# Work Order ID 89390

Item Name: Crosstube Low Standard Fwd

DRAWING NO. D212-664-147	TITLE CROSSTUBE ASS'Y (205 LOW FWD)	REV. B	<b>DART AEROSPACE LTD ENGINEERING ORDER</b>		D.E.O. NO. D212-664-147-B-1	SHEET NO. SHEET 1 OF 1	SCALE NTS
DRAWN <i>92</i>	CHECKED <i>ASS</i>	MFG. APPR. <i>183</i>	APPROVED <i>WV</i>		DE APPR. <i>WV</i>		
DATE 11.07.15	DATE 11.07.20	DATE 11.07.21	DATE 11/07/21		DATE 11.07.21

**D212-664-147/-147B**  
**ASSEMBLY DETAIL**

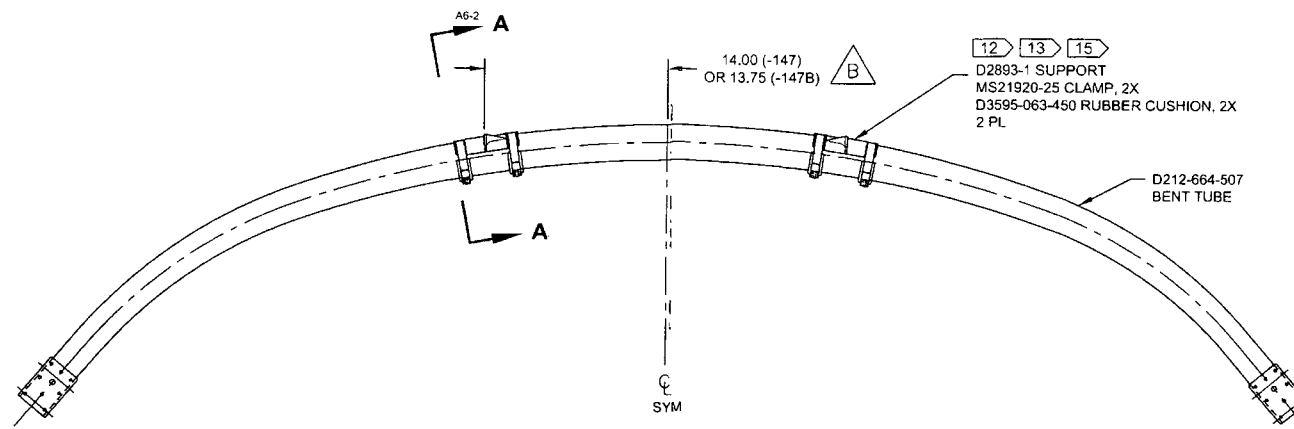
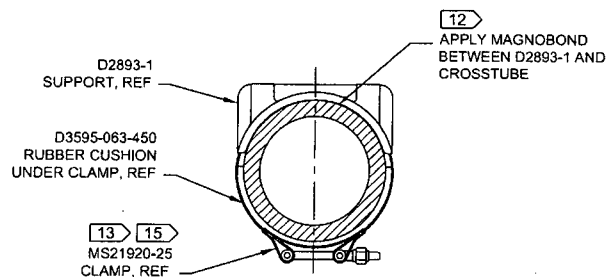
**PURPOSE:**

REPLACE MAGNOBOND WITH PROSEAL.

NOTE 12 & 15, SHEET 1 IS AMENDED AS FOLLOWS:

12) TO INSTALL D2893-1 SUPPORT: ABRASE MATING SURFACE OF SUPPORT AND CROSSTUBE WITH 180-GRIT SANDPAPER AND REMOVE RESIDUE WITH MEK (OR EQUIVALENT). APPLY A 0.04" TO 0.07" THICK LAYER OF PROSEAL 890 CLASS B-2 (OR AMS-S-8802 CLASS B-2) SEALANT TO MATING SURFACE OF SUPPORT.

15) TORQUE CLAMPS 80 TO 100 IN-LB. ENSURE AT LEAST 1.5 THREADS SHOWING IN SAFETY AND THAT NUT HAS NOT BOTTOMED-OUT AFTER TORQUING. **PRIOR TO PACKAGING, RE-CHECK TORQUE ON CLAMPS AFTER PROSEAL 890 SEALANT HAS CURED FOR 72 HOURS.**
